**COMMITTEE OF THE WHOLE (WS) – JUNE 5, 2024**

**COMMUNICATIONS**

**RE: Weston Road and Highway 7 Secondary Plan  
3883 Highway 7**

## Schedule 1 Weston 7 Land Use Designations

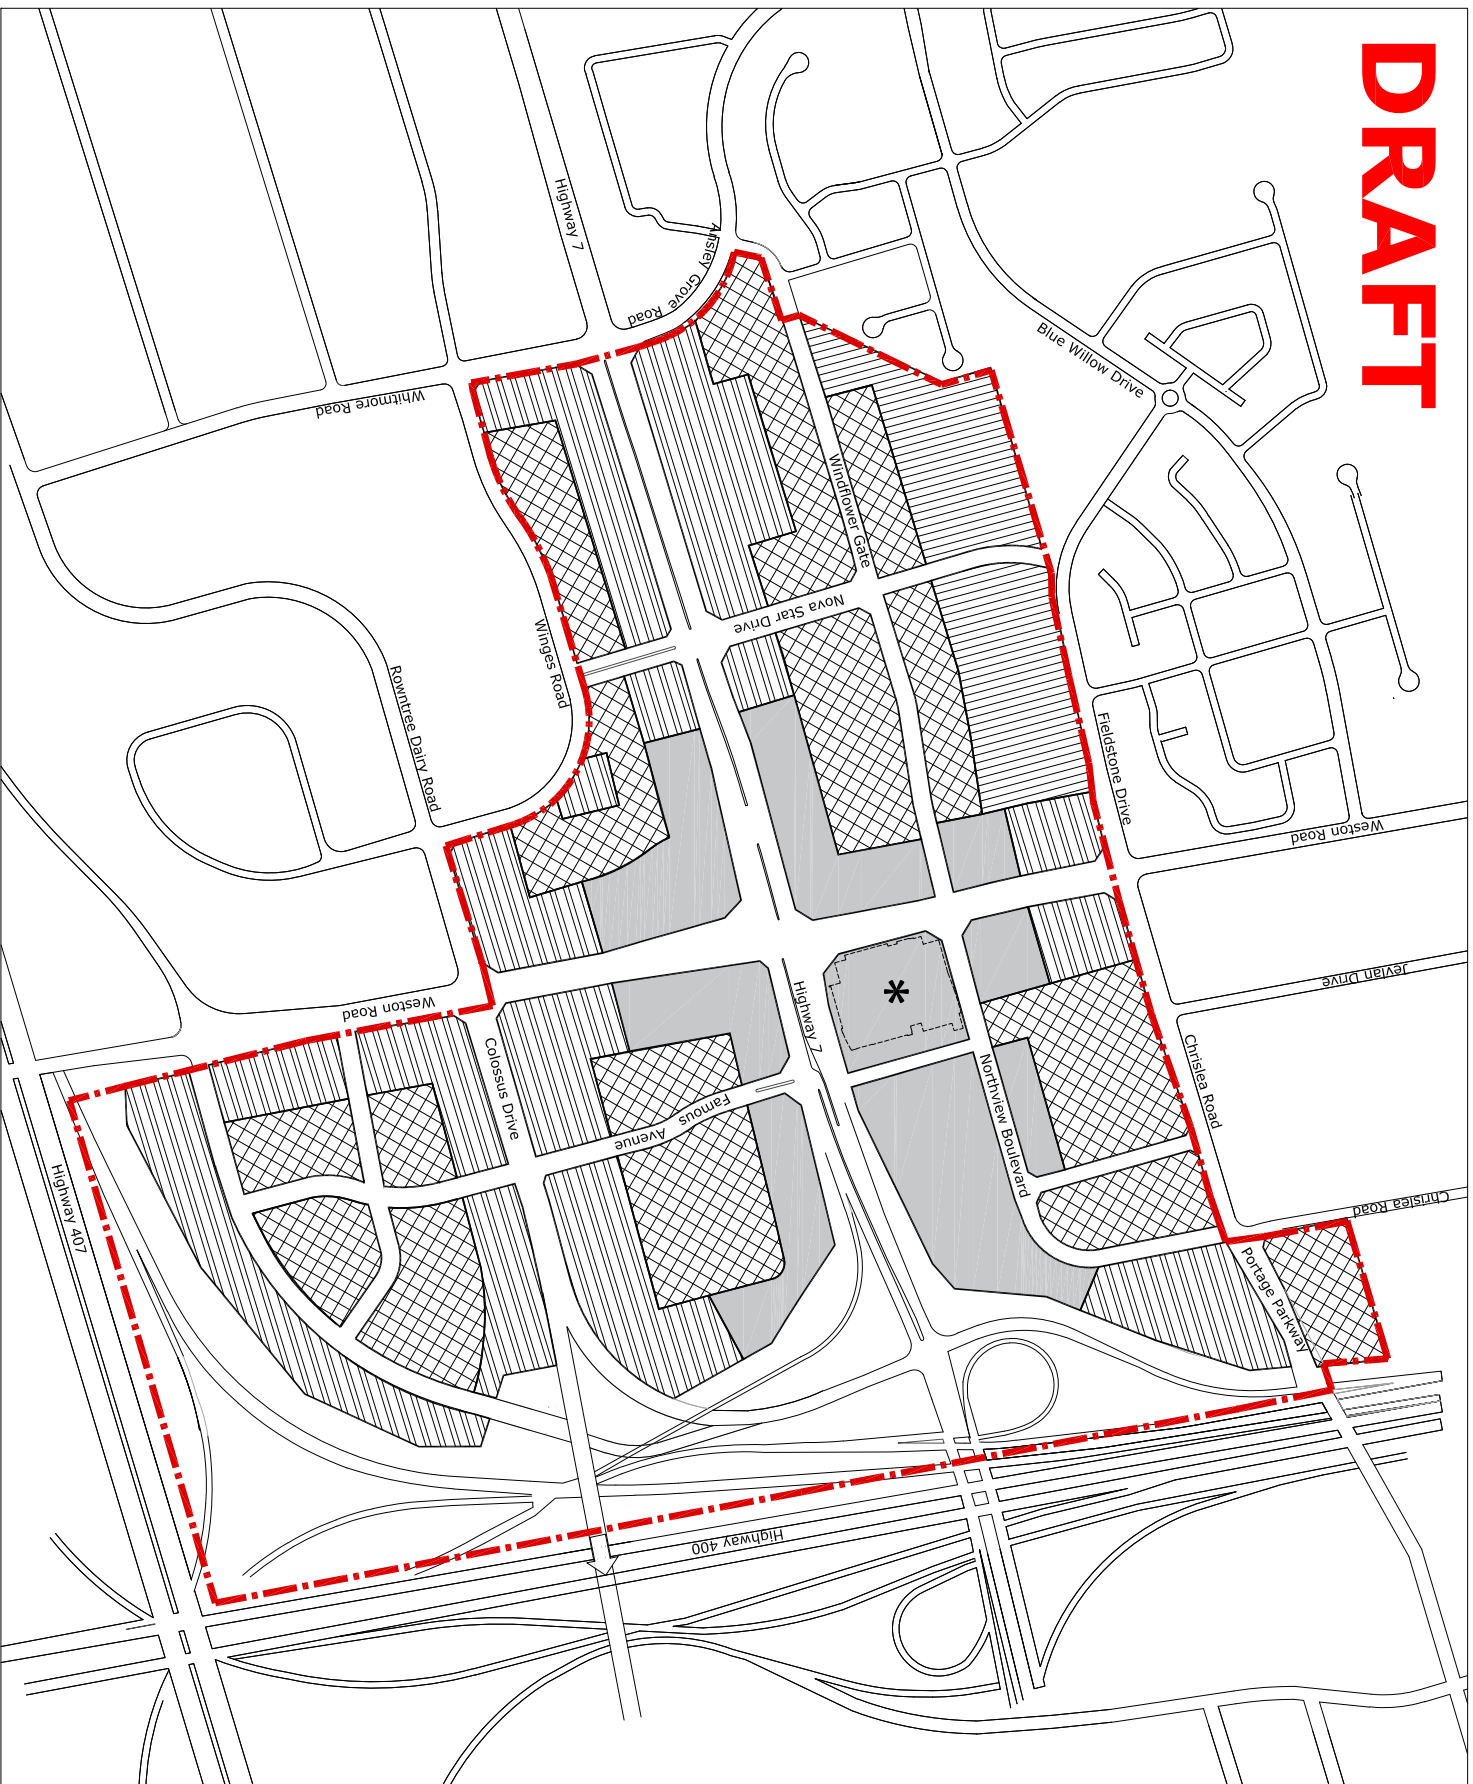
The draft land use scenario as shown on Schedule 1 of the Secondary Plan indicates that the majority of the Subject Property be used for an extension of Nova Star Drive. The remaining portion of the Subject Property is designated *Mixed-Use I*. We do not support the use of the Subject Property for an extension of Nova Star Drive and have identified that the remaining lands with the extension would be unusable for the purpose of any meaningful development.

An amended Schedule has been attached to this letter for your review and consideration as part of a further update to the Secondary Plan. The attached Schedule designates the Subject Property as *Mixed-Use* and does not include the extension of Nova Star Drive through the Subject Property. The proposed *Mixed-Use* designation for the Subject Property is consistent with the City of Vaughan Official Plan existing permissions that would allow for the fulsome full development of the lands through the future transformation of this area. We have submitted this schedule to Staff for their review and consideration as part of the Secondary Plan process and as part of our participation in ongoing meetings with Staff as a participating member of the Weston 7 Landowners Group.

It is our opinion that the extension of Nova Star Drive is not required to implement the goals and objectives of the Secondary Plan and should instead be designated as *Mixed-Use* as identified in Schedule 1 attached herein. Schedule 1 has been submitted to Staff and is proposed to be amended as indicated on the attached, which would provide maximum flexibility for the development of the lands including the request for removal of the maximum heights and densities. The proposed modifications are part of ongoing discussions and negotiations with Staff and the landowners group and part of the Secondary Plan updates.

Figure 1: S7SP - Proposed Schedule 1, Land Use Designations

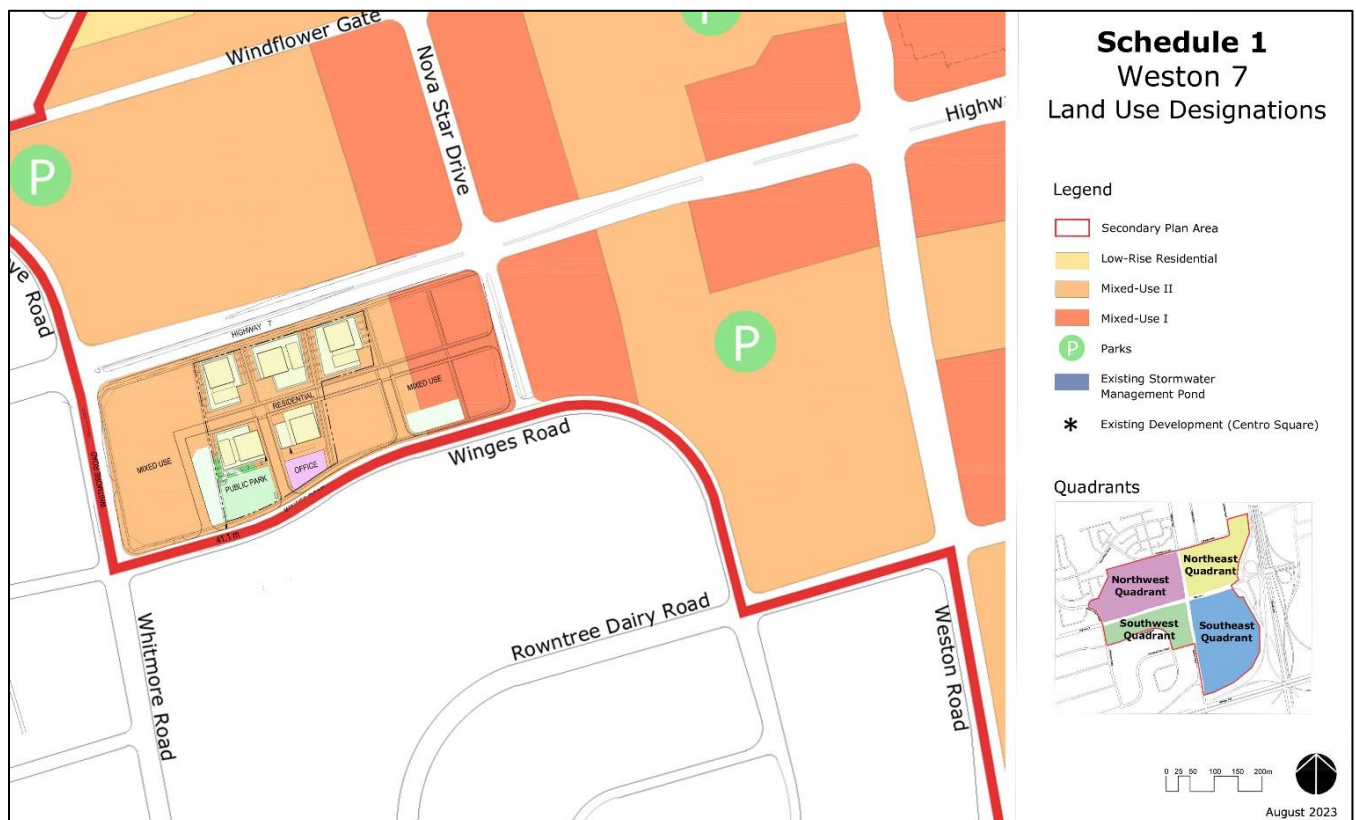
- Policy 5.3.3 e) within the Mixed-Use II designation, Mid-Rise Buildings should have a maximum FSI of 3.75, while High-Rise Buildings I should have a maximum FSI of 6.0, and High-Rise Building II should have a maximum FSI of 7.5. As rationalized in the following section as it relates to building height, it is our opinion that the proposed development is better identified as a High-Rise Building II site given its extensive frontage (150 m) along Highway 7, proximity to (2) MTSAs, and its frontage on multiple public roadways. Although phased, the development is being reviewed as a singular development and will be structured as such. As a combined development, the total proposed density is 8.62 FSI on a gross basis, which is only 1.12 FSI greater than the maximum permitted in the High-Rise Buildings II designation. It is our opinion that this modest increase is appropriate given other benefits the realization of this development will meet provincial mandates surrounding intensification while providing for a public park and 1,981 new residential units.

Figure 2: Schedule 2, Building Height

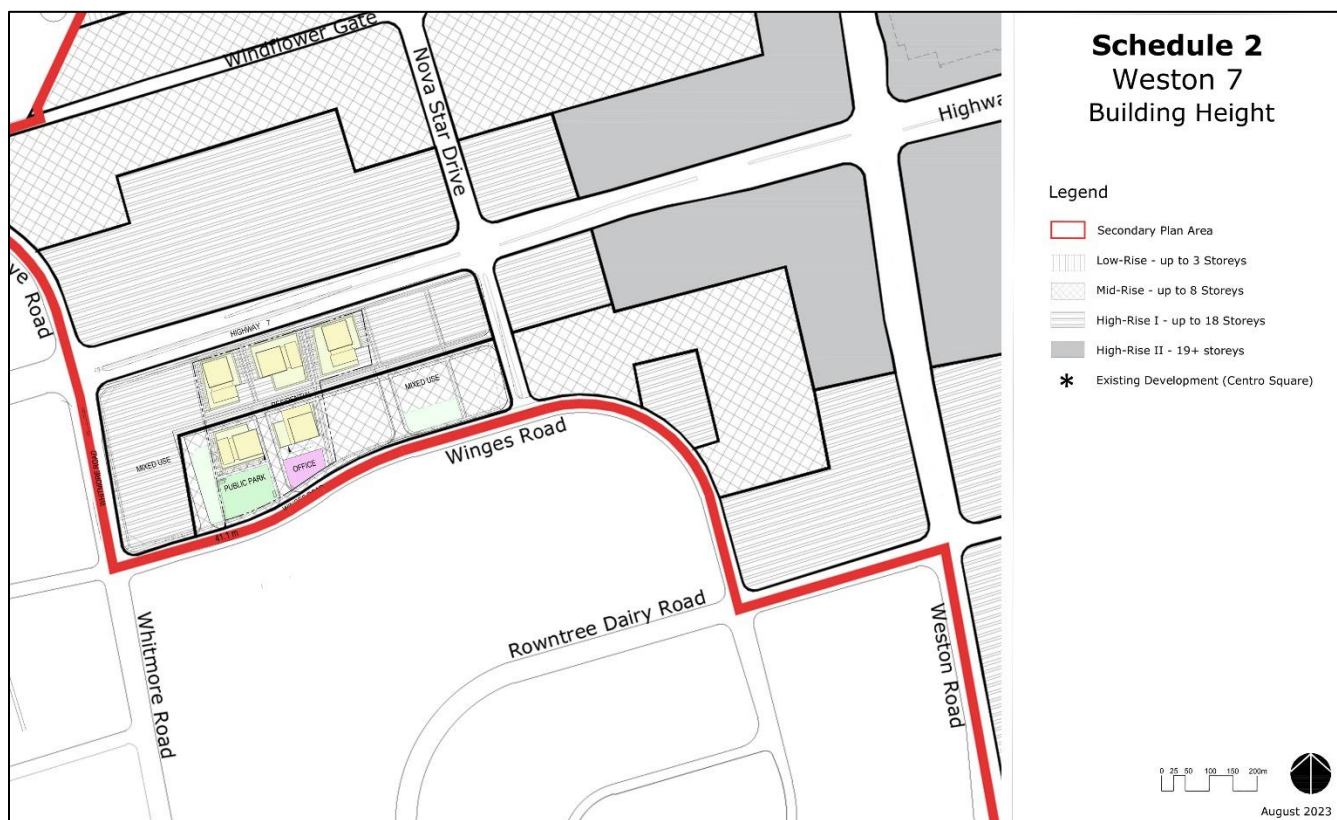
The proposed development is proposed to be have differentiated designations: *Mid-Rise, up to 8 storeys* (on the south side), and *High-Rise I up to 18 storeys* (on the north side) per Schedule 2, Building Heights, illustrated on Figure 2. As such, the (3) buildings along Highway 7 are proposed to be *High-Rise I*, while the (3) buildings to the rear are proposed to be *Mid-Rise*. The following comments are provided as it relates to building heights, as well as the policies contained in Section 4.2 of the W7SP.

- The site’s location on the southern portion of the W7SP area provides an optimal development scenario for greater heights and densities to be focused towards the south quadrants. The southern orientation of the site will limit shadow impacts onto the public realm and sensitive residential uses as the subject property is approximately 270 metres from any existing low-rise community areas, which satisfies Policy 5.5.3 f) of the W7SP.

Figure 4: Schedule 4, Transportation System

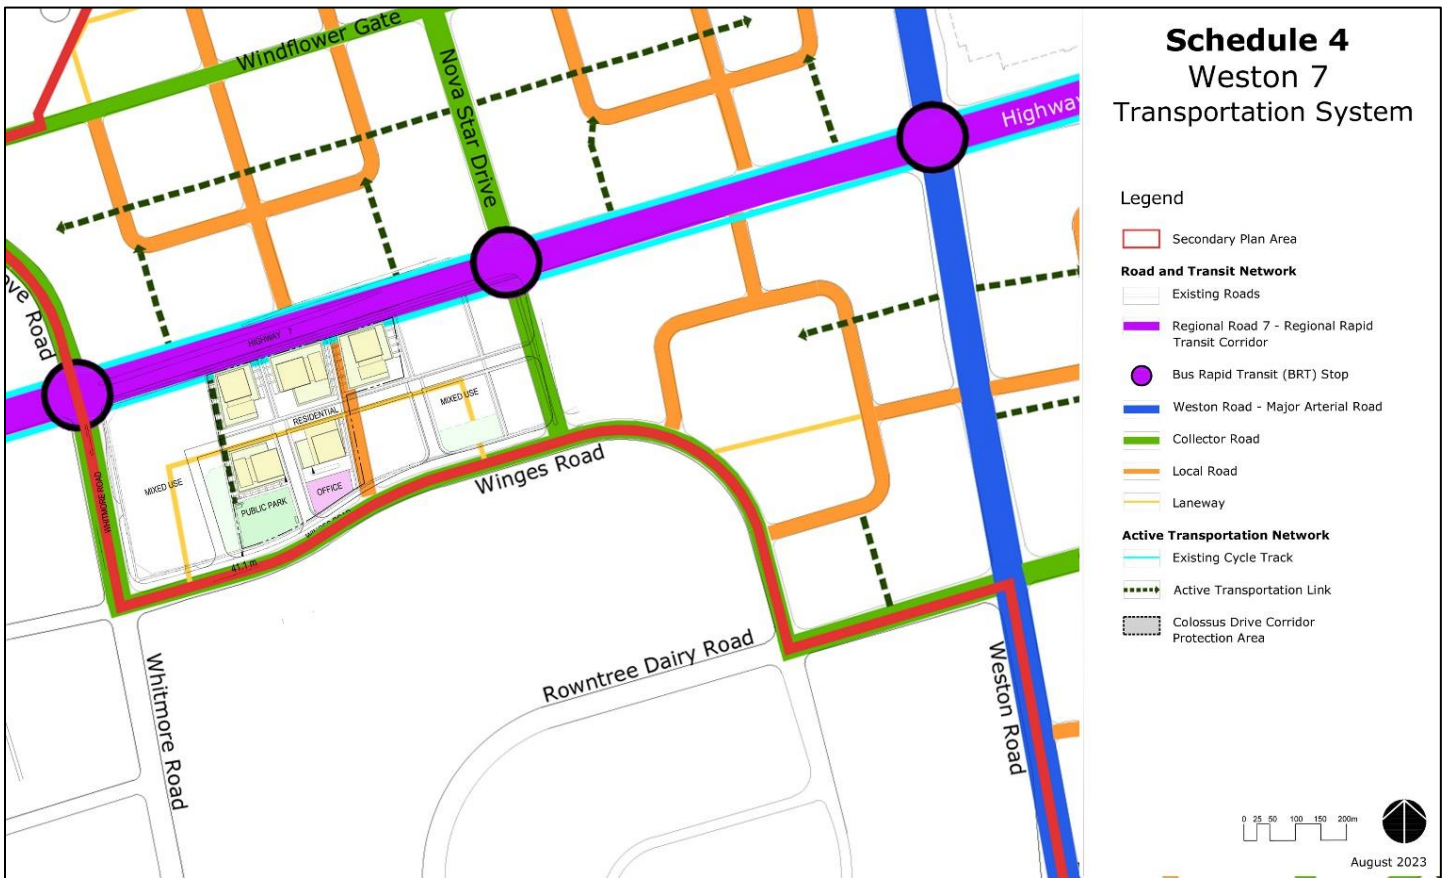
Crozier and Associates submits the attached Transportation Opinion Letter which concludes that although they are generally in support of the of the larger area-wide recommended transportation improvements, the new proposed north-south public road connection between the Nova Star Drive extension and Whitmore Road which bisects the Subject Property is not necessary from a traffic capacity perspective and would not be preferable from a safety perspective. The proposed new road will introduce additional conflict points between vehicles and non-auto transportation users and likely introduce significant cut-through traffic to the quadrant in an attempt for automobile traffic avoid delays and congestion issues at the critical Weston Road and Highway 7 intersection. Please refer to the attached Transportation Opinion Letter for additional discussion.
